Hydro One Brampton Networks Inc.
EB-2014-0083
Board Staff Interrogatories

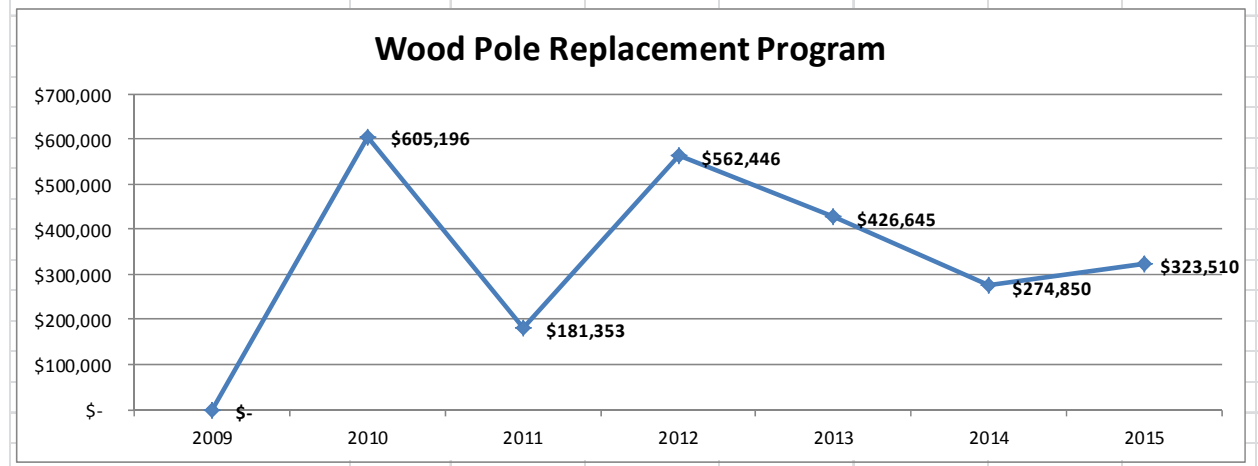
The Kinectrics Asset Condition Assessment at page 174 of the Kinectrics report suggested that, because age was the only available data for this category, it would assist the next ACA report if inspection maintenance records could be kept to determine the specific segments where failure is occurring. But at (Adobe) page 398 of the Distribution System Plan, Hydro One Brampton indicates that the *“strategic feeder cable replacement program has been designed to mitigate impact of unplanned cable replacements by using replacement metrics that are selective and consider cable age, loading and cable fault history. This program will install new feeder rated cables to improve...”* (Emphasis added)

- a) The underlined statements appear contradictory and in the case of the Feeder cable, it appears that all the Feeder cable is to be new, although the title indicates rehabilitation or replacement. Why would Kinectrics indicate that age was the only variable available for this category of data, when it appears Hydro One Brampton has additional data?

- b) Please clarify if the renewal (rather than rejuvenation) of Feeder cable is because it also requires upgrading to a larger cable? Is any feeder cable being replaced for condition reasons rather than for capacity reasons? Please clarify and Indicate where replacement and rejuvenation is to occur for Feeder cables?

- c) If the Feeder cable is not all new please indicate if the option of replacement and/or rejuvenation been decided upon in the same manner as for the Distribution Cables, i.e. by looking at the fault history?

Source: Distribution System Plan Appendix 2AA

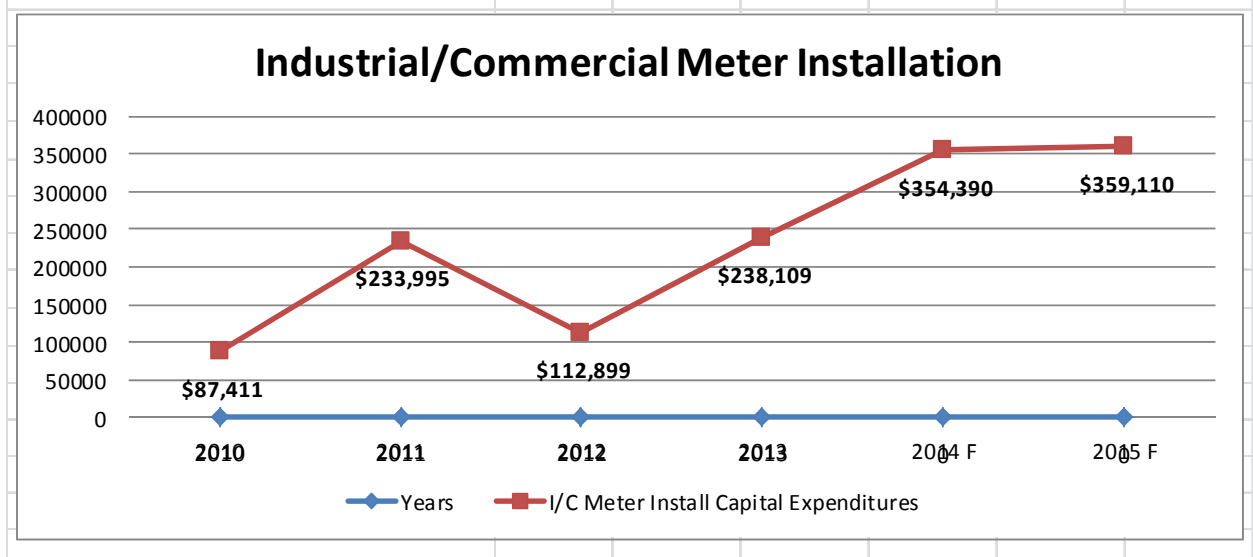
The actual and planned capital expenditures for the Industrial/Commercial Meter Installation program are provided at Appendix 2AA to the Distribution System Plan. The expenditures for the year 2010-2013 total \$672,414. In comparison, the forecast expenditures for two years, 2014 and 2015 together total \$713,500. Staff observes that Hydro One Brampton is proposing to spend more on this program in the next two years than it has in total over the preceding 4 year period, from 2010-2013. Staff also observes that the 2014 expenditure is 49% higher than 2013 actual.

- a) Hydro One Brampton states that it is undertaking this program to comply with Measurement Canada regulations requiring “all retail electricity customers to have a revenue class meter installed for measuring and

billing electricity use”. Please confirm that this is an ongoing requirement, rather than a new one.

- b) If there are new requirements necessitating increased action on the part of Hydro One Brampton, please indicate what steps were considered by Hydro One to mitigate the increased expenditure. For example, did HONI consider establishing a more stable and predictable pace at which the program could have been rolled out?
- c) Please explain how the 2014 and 2015 capital expenditure forecast for the above referenced capital program was developed and provide a high level breakdown of the main project components that support the requested capital expenditure. In your response please provide (i) the assumptions that underpin the forecast, (ii) reason(s) for a 49% increase in program spending in 2014.
